United States Patent and Trademark Office

APPLICATION NO.	FILING DATE	FIRST NAMED INVENTOR	ATTORNEY DOCKET NO.	CONFIRMATION NO
10/635,631	08/05/2003	Hiroyuki Kusaka	026304-0208	8454
23392	7590 02/21/2006		EXAMINER	
FOLEY & L	ARDNER RY PARK EAST		NGUYEN, PH	UONGCHI T
SUITE 3500	KI I MKK LADI		ART UNIT	PAPER NUMBER
LOS ANGEL	ES, CA 90067		2833

Application No.	Applicant(s)			
Office Action Summary		10/635,631	KUSAKA, HIROYUKI			
		Examiner	Art Unit			
		Phuongchi Nguyen	2833			
	The MAILING DATE of this communication appears on the cover sheet with the correspondence address Period for Reply					
A SHORTENED STATUTORY PERIOD FOR REPLY IS SET TO EXPIRE 3 MONTH(S) FROM THE MAILING DATE OF THIS COMMUNICATION. - Extensions of time may be available under the provisions of 37 CFR 1.136(a). In no event, however, may a reply be timely filed after SIX (6) MONTHS from the mailing date of this communication. - If the period for reply specified above is less than thirty (30) days, a reply within the statutory minimum of thirty (30) days will be considered timely. - If NO period for reply sepecified above, the maximum statutory period will apply and will expire SIX (6) MONTHS from the mailing da

AHACGINENT 1

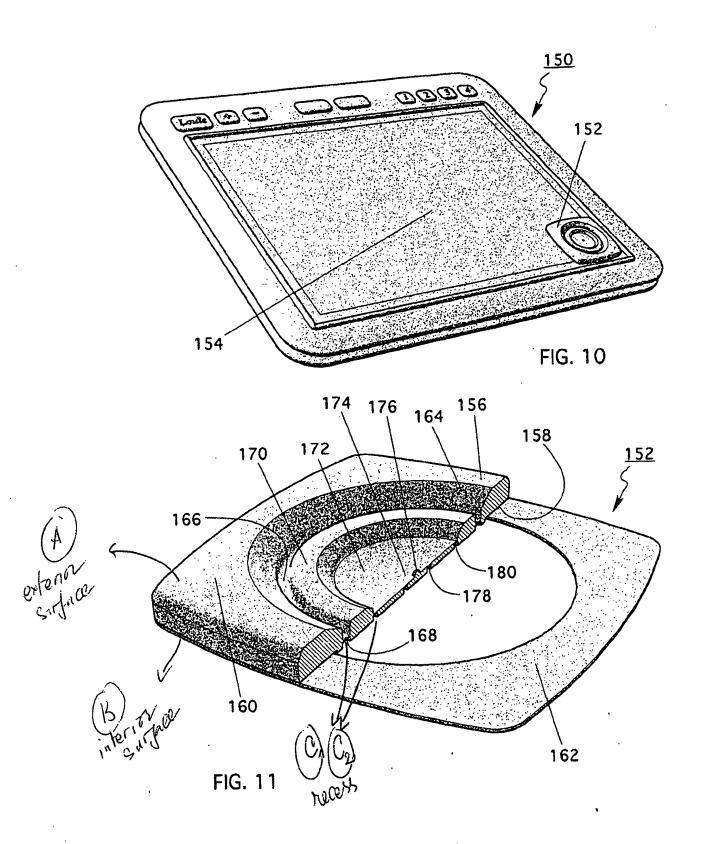
In regarding to claims 1 and 16, Louis et al disclose (Attachment 1 of figure 11) an electronic apparatus comprising a housing (of 150, of 160 and 12) which contains an electric component (col. 6, lines 3-5; Fig. 2 teaches a schematic of the computer system which would inherently include the plurality of the electrical components to operate the computer system including the electric component) therein (because figure 11 is an embodiment of figures 1-2; and the flat input surface 16 of figures 1-2 is equivalent to the flat input surface 154 of figure 11), and has an outside wall (C) which has an exterior surface (A) exposed outward of the housing (of 150, of 160, 12) and an interior surface (B) exposed inward of the housing (of 150, of 160, 12) having an operation area (172) in the exterior

In regarding to claim 2, Louis et al disclose (Attachment 1) the electronic apparatus wherein the operation area (172) has a recess (180) formed on the exterior surface (A).

In regarding to claim 3, Louis et al disclose (Attachment 1) the electronic apparatus wherein the operation area (172) has a projection (156 or 170) formed on the exterior surface (A).

In regarding to claim 6, Louis et al disclose (Attachment 1) the electronic apparatus wherein the operation area (172, 174, 176) is made with a surface roughness different from a surrounding area.

In regarding to claim 9, Louis et al disclose (Attachment 1) the electronic apparatus wherein the operation area (172) has a plurality of projections (156, 170) provided therein.

In regarding to claim 10, Louis et al disclose (Attachment 1) the electronic apparatus wherein the operation area (172) has a first operation area (176) for first operation, and a second operation area (174 or 172) provided separately from the first operation area (176) for second operation (figure 12 and column 10, lines 64-67 and column 11, lines 1-6).

In regarding to claims 18 and 20, Louis et al disclose (Attachment 1) the electronic apparatus further comprising a recess (180) formed on the exterior surface (A) of the outside wall, wherein the sticker (162) covers the recess (180, 166), and the flat input surface (154) of the pointing device (of 154) is laid on the interior surface (B) opposing the recess (180, 166).

In regarding to claim 19, Louis et al discloses the electronic apparatus (attachment 1) further comprising a sticker (162) printed with a pattern, the sticker (162) being secured to the exterior surface (A) of the outside wall opposite to the interior surface (B) on which the flat input surface (154) of the pointing device (of 154) is laid.

In regarding to claim 21, Louis et al further discloses a sticker (162) that is stuck to the operation area (172) (figure 11).

Atlachment 2

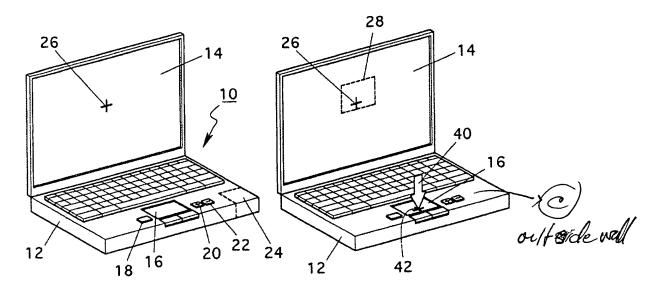
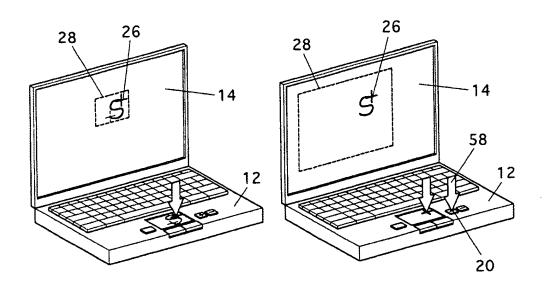
surface (A); and a pointing device (of 154) having a flat input surface (154) secured with an adhesive (162) on the interior surface (B) of the outside wall adjacent the operation area (172), the outside wall (C) being larger than the flat input surface (154) (or 16 of fig. 1B) (attachment 2), the flat input surface (154) receiving input operations through the operation area (172); and a sticker (162) stuck to the operation area (172). Louis et al discloses the invention generally all as claimed, but lacks a colored sticker. However, Mack et al teaches a colored sticker (70) stuck to the operation area (60) (fig. 7; page 3, [0023], lines 26-28). It would have been obvious to one having ordinary skill at the time the invention was made to modify the operation area of Louis et al by having a color sticker stuck to the operation area as taught by Mack et al for the user to be visible during operating the computer.

In regarding to claim 8, Louis et al disclose (Attachment 2) the electronic apparatus wherein the operation area (172) has a plurality of recesses (166, 180) provided therein.

In regarding to claim 22, Louis et al discloses the operation area (172) has a recess formed on the exterior surface (C) (attachments 1 and 2).
